**SIERRA CLUB
VALLEY WATCH
CITIZEN ACTION COALITION**

December 26, 2007

**Re: Public Comments on Draft Prevention of Significant Deterioration
Construction Permit for Duke Energy Indiana-Edwardsport Generating
Station, Significant Modification No. 083-23529-00003, Significant
Permit Modification No. 083-23531-00003**

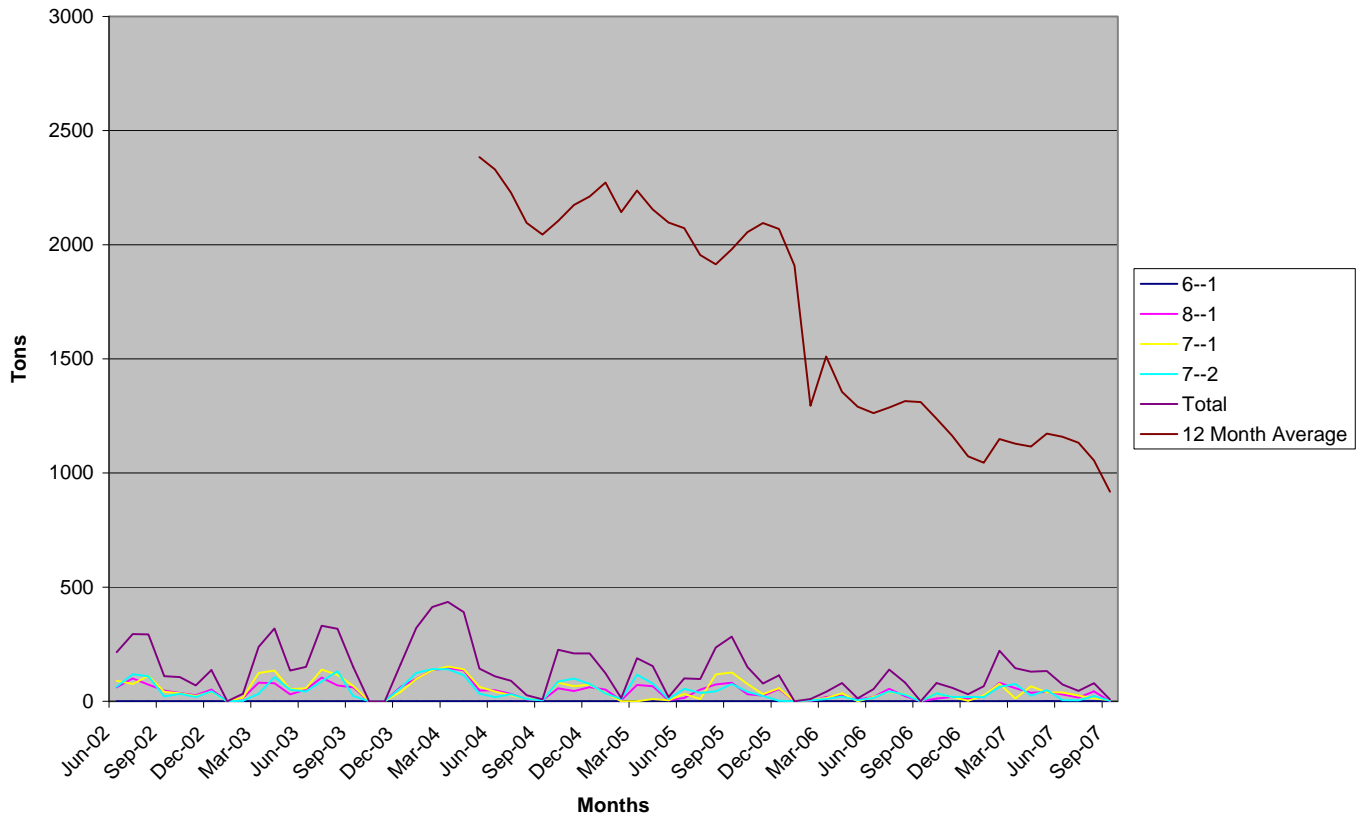
The “netting” analysis done for the proposed project includes a number of errors, including the following:

- Use of a “baseline” outside of the 5-years preceding project construction.
- Failure to exclude noncompliance emissions, or those emissions exceeding the “allowable” emissions, from the “baseline” emissions.

- Failure to account for the fact that the declining emissions from the existing units do not have the same qualitative significance of constant emissions from the new units for their 30+ years of life.
- A. IDEM Unlawfully Uses June 2002 through May 2004 as the “Contemporaneous” Period for Calculating a Net Emissions Decrease.

Total NOx Emissions

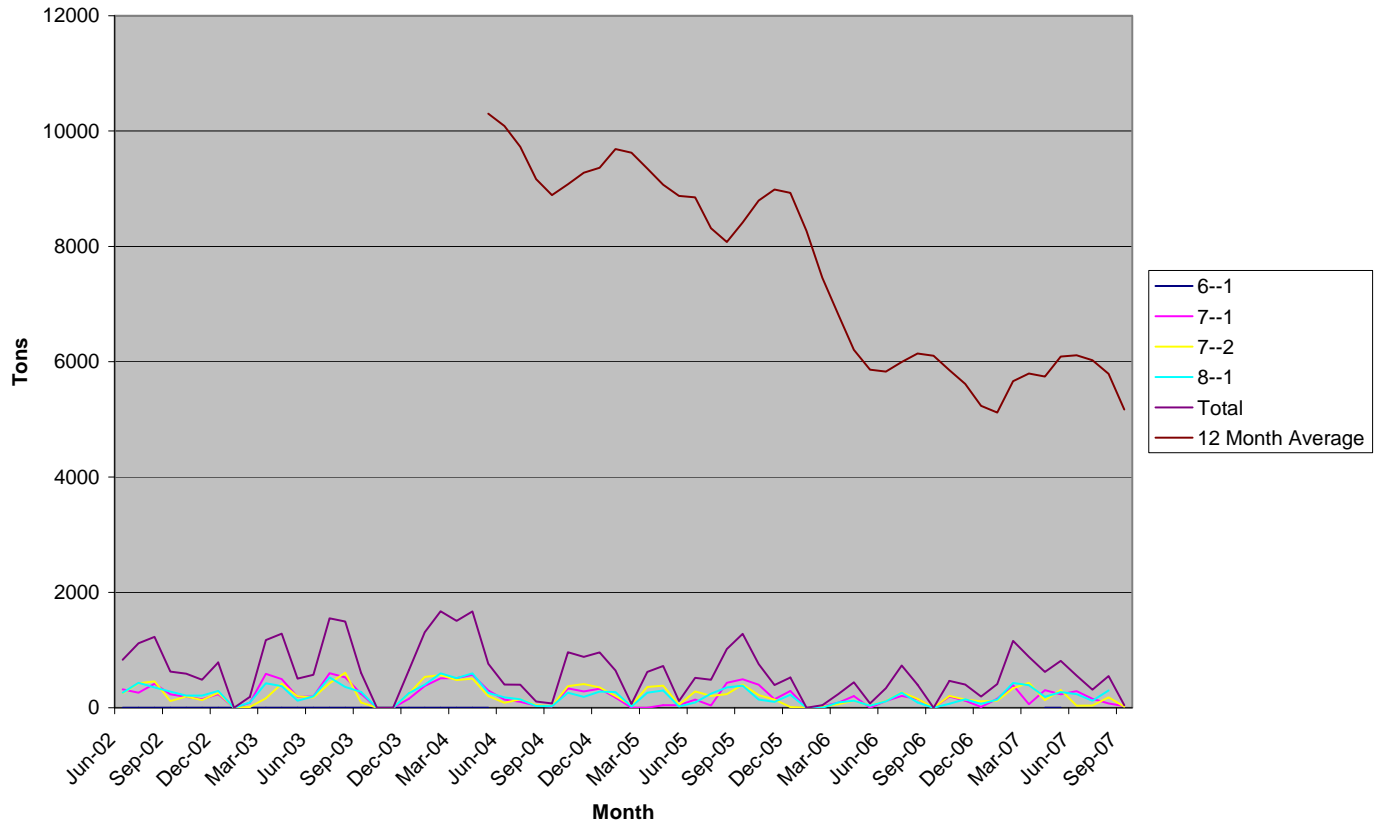
In Appendix A to the TSD, IDEM calculates the “baseline” emissions of SO₂ and NO_x as the emissions during June, 2002, and May, 2004. TSD at 24. This is unlawful. In its application, Duke misstates the law as allowing the baseline to be any 24-months during the 5 years prior to its *application*. Application at 26 (stating that “As defined in 326 IAC 2-2-1(e), ‘baseline emissions’ means... Within the 5-year period immediately preceding the date a complete permit application is received by IDEM.”) What the law actually states is that the baseline emissions must be “within the five (5) year period immediately preceding when the owner or operator begins actual construction of the project.” 326 IAC 2-2-1(e)(1); *see also* 326 IAC 2-2-1(jj)(2)(A) (requiring that a contemporaneous decrease occur within “five (5) years before construction of the particular change occurs.”).

This is an important correction from Duke's misrepresentation because the "baseline" period relied upon by Duke and IDEM does not fall within the five years preceding actual construction. Construction can commence, at the earliest, in January, 2008. Therefore, the earliest five year period would be January, 2003 through December, 2007. Presumably construction will not commence immediately after issuance of the PSD permit, resulting in a five year period running from later in 2003. Because the emissions from the existing emission sources (Boilers 6-1, 7-1, 7-2 and 8-1) decreased steadily over time, as shown in the tables below and in the attached tables, updating the "baseline" results in a smaller "decrease" attributable to shutting down the units.

Adjusting the “baseline” to the highest 12 month average from 24 months within 5 years preceding the January, 2008, earliest date when construction can commence, results in a reduction in the “decrease” attributable to shutting down the existing units of 114.4 tons of NO_x (2,272.5 tons, rather than 2,383.9 tons) and 610.4 tons of SO₂ (9,688.7 tons, rather than 10,299.1 tons). If construction on the new units does not begin until sometime in spring of 2008, or later, the creditable decreased emissions from shutting down the existing units are even less. This is likely since “commence construction” for purposes of PSD permitting, requires more than site preparation work, which will generally occur for several months before construction can commence for purposes of PSD.
